INDESIT company

Model type:
AVXXL105EX

Commercial code:
F033723

n1040398: Programme keys aligned.

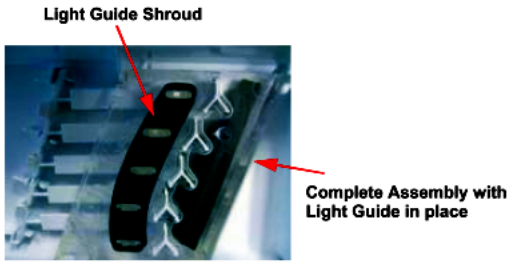
From serial no. 51118.0001, a specially shaped foam pad has been inserted between the keypad and light guide on washing machines AVXXF and AVXXL and washer-dryers AMFFX and AMXXL. The part code of this new component is C00142393 (fig. 001).

This new part separates the keys and pushes them outwards together to ensure they are perfectly aligned.

The pictures in figures 002 and 003 illustrate how the foam pad should be fitted on the keypad and subsequent assembly of the light guide with relative light guide bracket, code C00142648.

The new parts C00142393 and C00142648 can also be used on premodification appliances.

n4008c02: Rear drum replacement

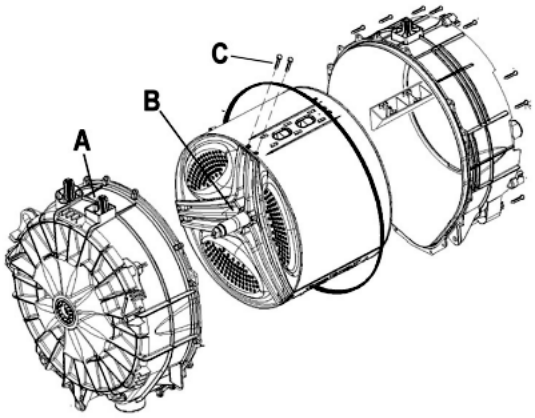
All drum service replacements use 35mm bearings

When you use in assistance the rear drum you will also need to change the drum bearing spider from the 30mm version to the 35mm version

A = C00119357 Drum Rear
B = C00117329 Drum Bearing Spider
C = C00201310 Drum Bearing Spider screws (Qty 6)

Production use 3 screws but for Service we suggest that 6 screws are used.

n0508c01: Door Gasket Clamp Band

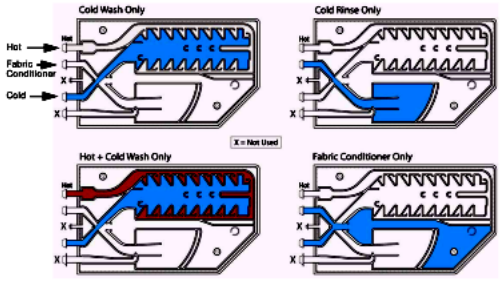
A New Polypropylene Gasket clamp band has been introduced in production from Serial number 80325.0000
The purpose is to provide added support to the inner rim of the door gasket.
